Glamour Dresses Limited

17th February 2021

Buildings Information

Permit layout from LGED for 6 storied building

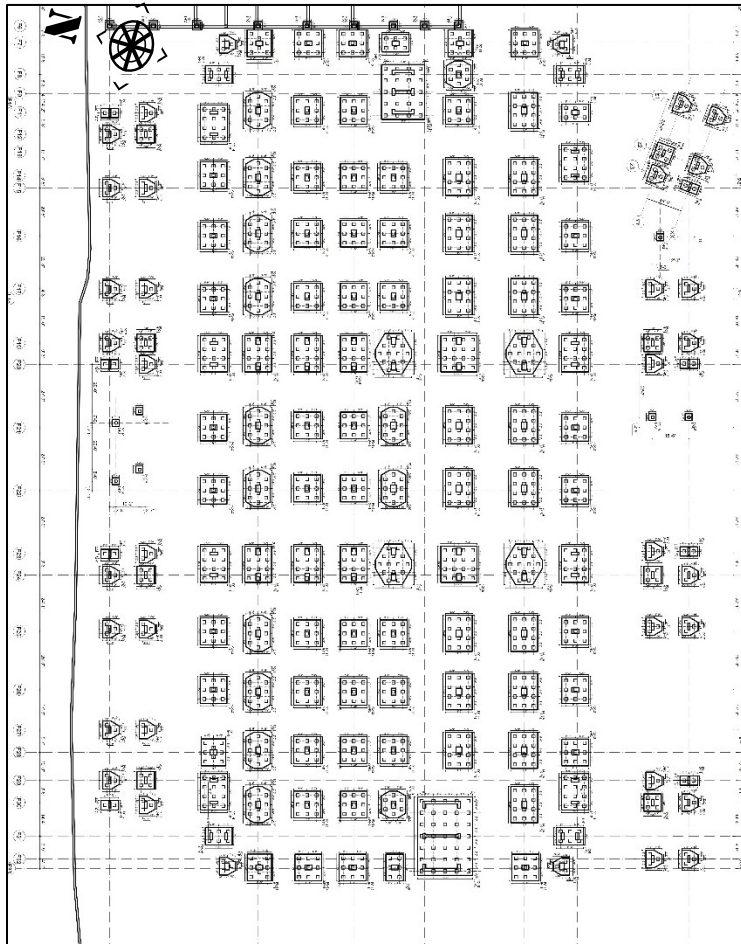
Future Vertical Extension

The building permit layout is for six storied structure. The building can be extended vertically in future. Design report of the structure was done for six storied structure. Till the date of this inspection, building was constructed up-to two stories. Prior to vertical extension above six stories, factory engineer is required to produce Detailed Engineering Assessment (DEA) for the further vertical extension of the structure according to BNBC and submit to RSC for review.

Pile layout of Utility Building

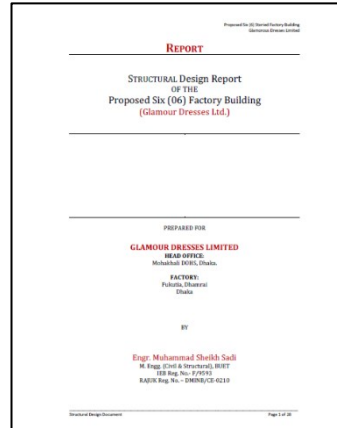
Stress in foundation exceeds normal design limit

Cursory calculation indicates that the stress in foundations of the highlighted area exceeds normal design limit considering live load 12 kPa (250 psf) on ground floor, 7.2 kPa (150) at mezzanine and 4.8 kPa (100 psf) at 1st floor, 2nd & roof floor (As per provided load plan). These footings found stressed in excess of normal design limit against the soil bearing capacity available from Geotechnical investigation report. Building engineer is required to carryout foundation adequacy check to justify the load carrying capacity.

Also, Adequacy check of the foundation has not been provided in the design report for the Utility Building. Factory Engineer is required to incorporate the adequacy check for foundation of the structure in the Engineering Assessment (EA) report.

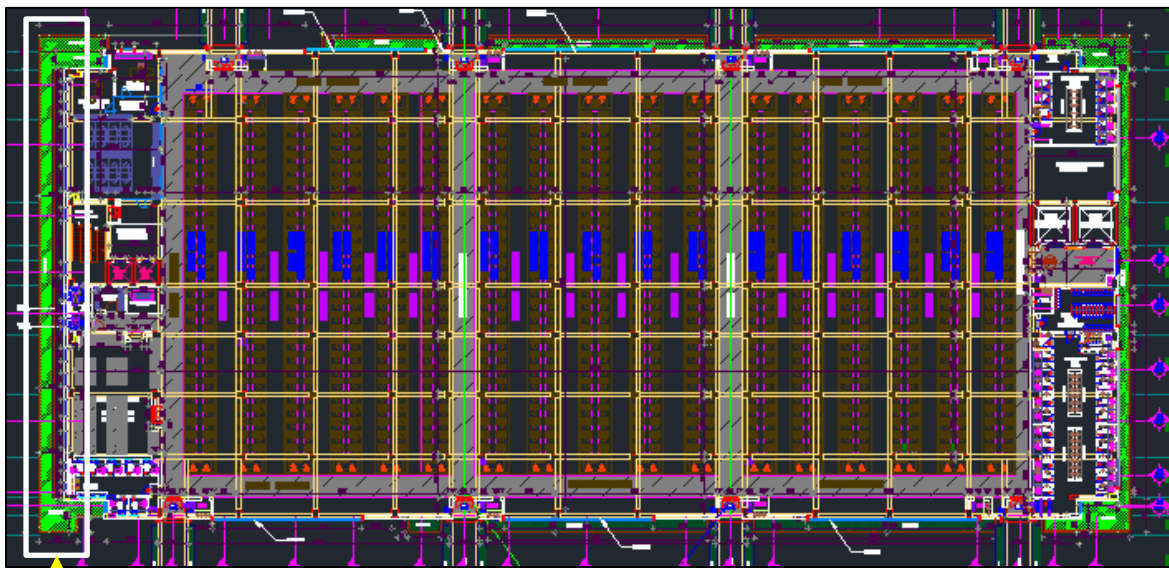
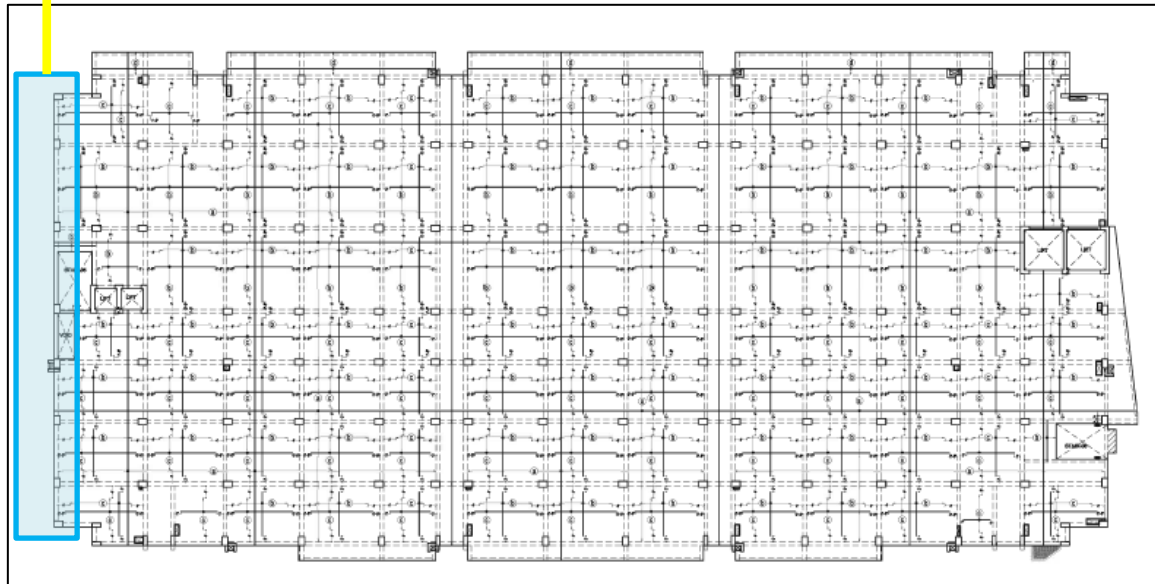
Design report prepared for six storied building. Pre-cast pile has been used as foundation with pile size 400 X 400 mm (16 X 16 inches) and pile length 11 m (36 feet).

The building has been designed for six storied. Till date of inspection, construction of the building was completed up to two stories with a mezzanine on the ground floor. Adequacy check of the foundation has not been provided in the design report for the Production Building. Factory Engineer is required to incorporate the adequacy check for the structure in the DEA.

Cantilever slab has been shown in architectural drawing

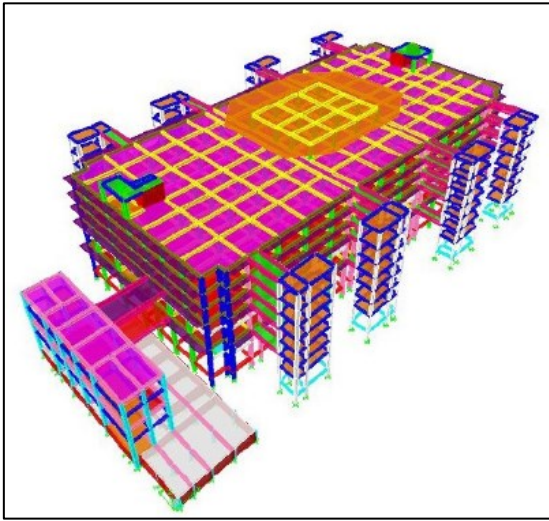
No information of cantilever slab shown in structural drawing

In architectural drawing, 3.05 m (10 feet) cantilever slab has been shown with garden facilities at 3rd floor, 5th floor and roof floor. In design report loading has been considered 9.6 kPa (200 psf) for garden area. In structural drawing, no details of the cantilever slab has been provided. Also, the adequacy check of the cantilever slab has not been incorporated in design report.

Factory engineer is required to check the adequacy of 3.05 m cantilever slab and incorporate the information in structural drawing and Detailed Engineering Assessment (DEA) in case of vertical extension.

Live load table of design report

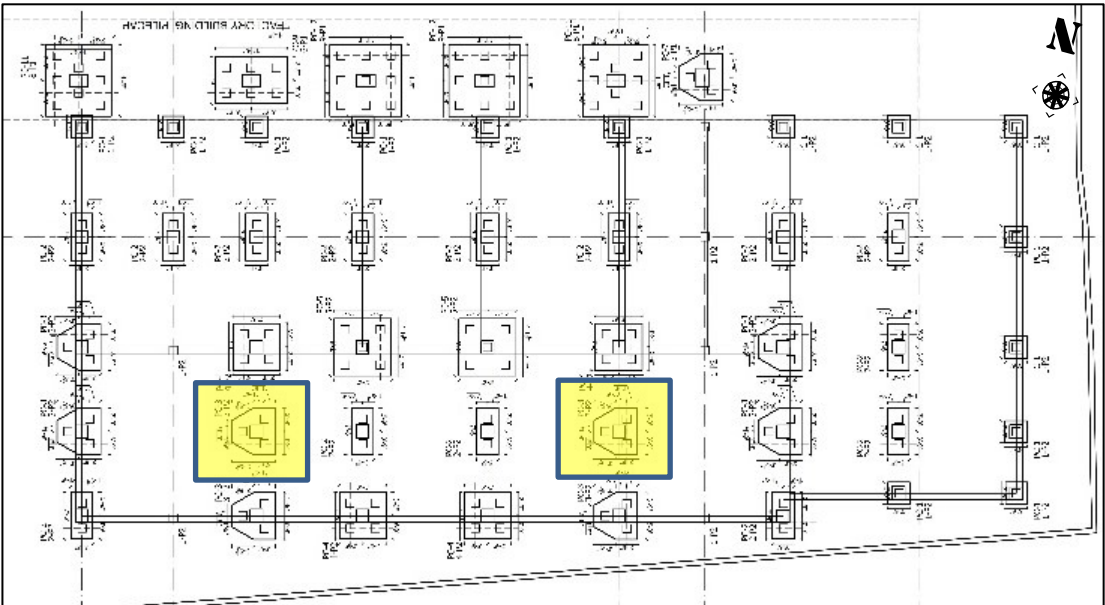
A live load table has been shown in drawing providing the live load consideration for different occupancies. But the live load plan was found only from 1st to 2nd floor (Existing roof). The live load was not available for the upper floors.

Factory engineer is required to prepare proposed live load plan for all the floor plates.
